URGENT Field Safety Notice

Philips Allura Xper R7.6- R8.1 systems

Delay of installation of the Lifetime Extension (LTE) kit in Allura Xper R7.6-R8.1 systems may lead to a broken propeller motor clamping bolt and a broken X-ray tube locking bolt.

Date: 11-Nov-2024

Figure 1: Clamping bolt of the C-arm propeller drive

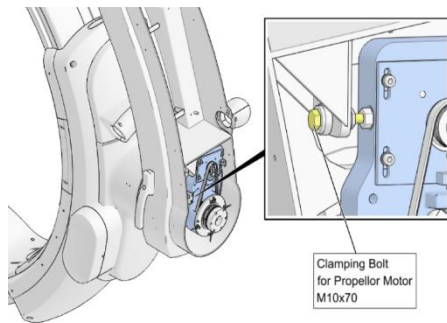
Philips has identified potential safety issues with delayed LTE kit installations for Allura R7.6-R8.1 systems exceeding 10 years of life. The kit includes a propeller motor clamping bolt (see Figure 1) and the X-ray tube locking bolt (see Figure 2). If one of these bolts breaks, part of the system will not function as expected.

If the installation of the LTE kit is delayed, breakage of the propeller motor clamping bolt and/or the X-ray tube locking bolt may be expected. If this occurs,

- The broken propeller motor clamping bolt may cause erratic C-arm movements, and potentially colliding with patients or bystanders (see Figure 3). These unbalanced movements may also cause the system to falsely detect a collision, consequently blocking motorized C-arm movements.
- The broken X-ray tube locking bolt may cause the tube to hit the cover, causing unexpected noise and the appearance of a black area (maximum up to 25%) on the X-ray image. Consequently, the area of interest in the X-ray image may be obscured, leading to the need for an additional scan.

A broken propeller motor clamping bolt could cause erratic C-arm movements, potentially resulting in the tube or the detector hitting staff or patients, leading to minor physical injuries (Example: hematoma/bruises, scratches, small cuts, or skin abrasions). Additionally, these erratic movements may trigger false collision detections, blocking all C-arm motorized movements and potentially delaying diagnosis or treatment.

Philips will contact all affected customers to arrange for a Field Service Engineer visit to install a Lifetime Extension Kit (reference FCO72200598). As of the date of this Urgent Field Safety Notice, Philips expects the solution to be available by Q1 2025.

Figure 2: Locking bolt of the X-ray tube

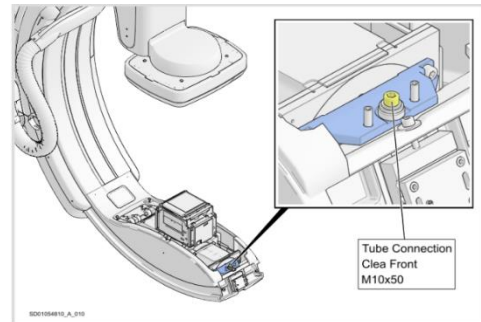
A broken X-ray tube locking bolt could cause a black area to appear on the X-ray image, which may obscure the area of interest. This may require repeat imaging (up to 1 or 2 additional X-ray images or 3D scans), leading to additional radiation exposure. However, this additional radiation is not expected to exceed the thresholds for tissue reactions set by the International Commission on Radiological Protection (ICRP) for the risk of illness or injury.
